**VILLAGE REVIEW BOARD**

**VILLAGE REVIEW BOARD AGENDA  
TUESDAY, OCTOBER 20, 2020  
7:15 P.M.**

### DRAFT COMBINED FINDINGS OF FACT REQUEST FOR CERTIFICATE OF DEMOLITION AND CERTIFICATE OF APPROPRIATENESS FOR ADDITIONS AND ALTERATIONS TO EXISTING STRUCTURES VILLAGE REVIEW BOARD

**PROJECT NAME:** Partial Demolition and Two-Story Addition (Garage / West Side of Building)

EXHIBIT A. Detailed professionally constructed architectural CADs: EL1

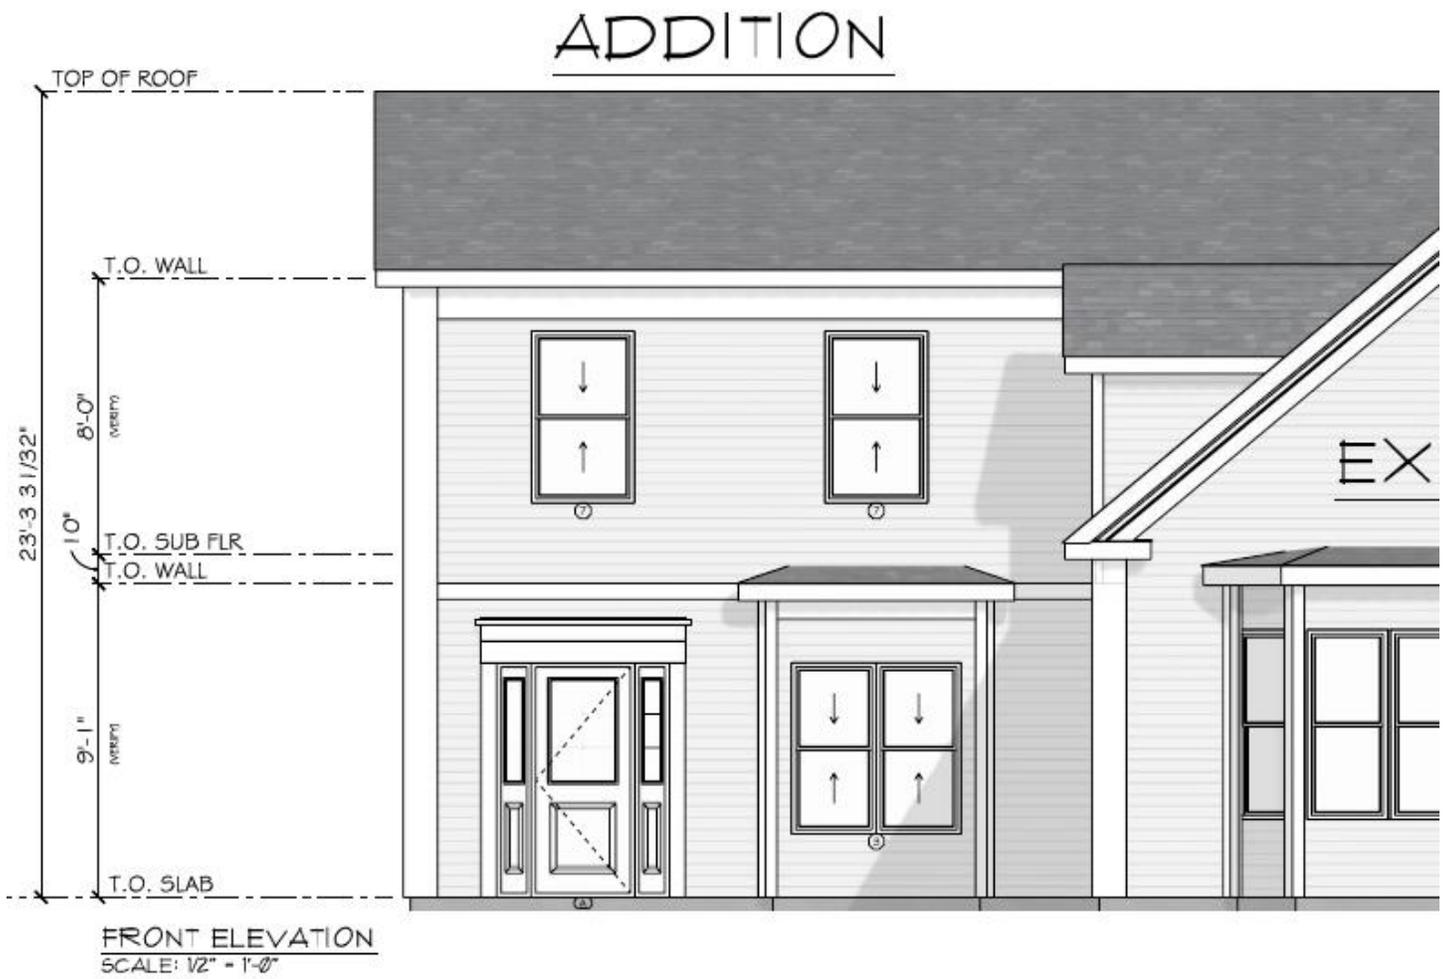
The proposed project does not require the use of dumpsters and the elevations provided do not indicate any mechanical equipment located within 25 feet of the public right-of-way. The applicant shall confirm this for the VRB.

As shown on the submitted elevations, the proposed project does not include any rooftop mounted HVAC or energy producing equipment, but the applicant should confirm this for the VRB.
